Rezoning Transportation Analysis

Petition Number: 2025-094

Date	Description
09-24-25	First Review (TM)
10-23-25	Second Review (TM)
01-28-26	Third Review (BH)

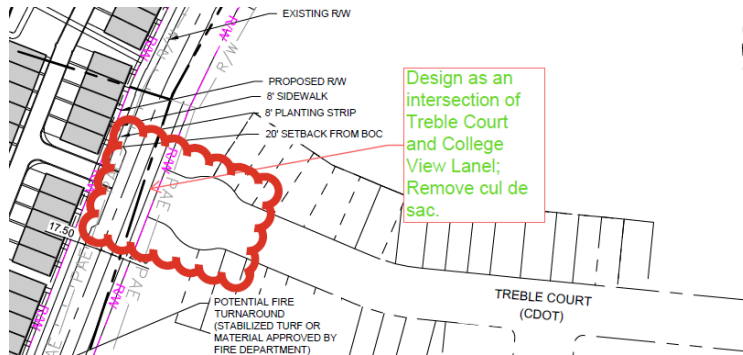
4. ~~Revise Site plan and conditional note(s) to commit to connecting the proposed roadway extension of College View Lane to Silver Birch Lane. Add a conditional note committing to this improvement and revise callout on site plan committing to connecting the roadway.~~

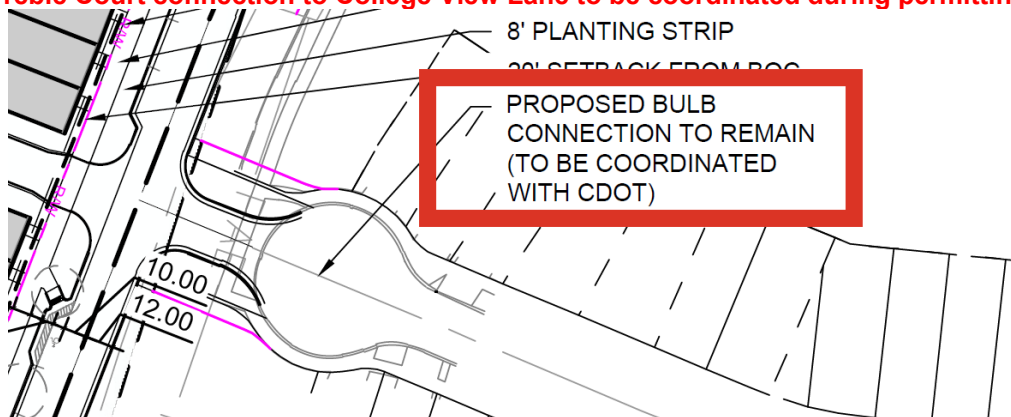
5. ~~Revise Site plan and conditional note(s) to commit to connecting the proposed roadway extension of College View Lane to existing Treble Court. The cul de sac is to be removed, and the intersection is to meet CDOT alignment standards. Add a conditional note committing to this improvement and add a callout on site plan committing to connecting the roadway.~~

New Clarifying Comment 10-23-25: Revise site plan by revising callout to say final design of Treble Court connection to College View Lane to be coordinated during permitting.

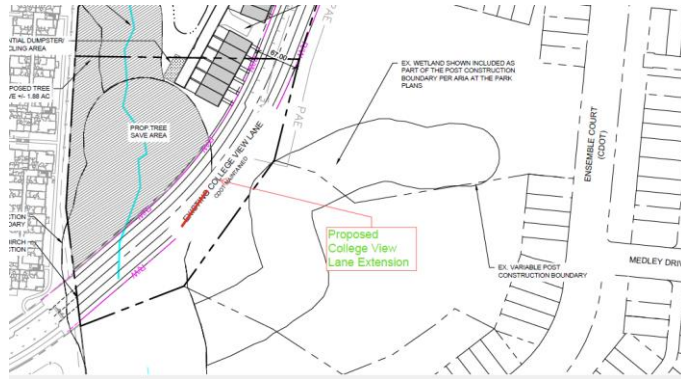
6. ~~Revise site plan and conditional note(s) to commit to constructing an 8-foot planting strip and an 8-foot sidewalk along Ashmore Square Road Extension and Alexander Road. Site plan shall callout and dimension sidewalk and planting strip from the roadway centerline. Add a conditional note committing to this improvement.~~
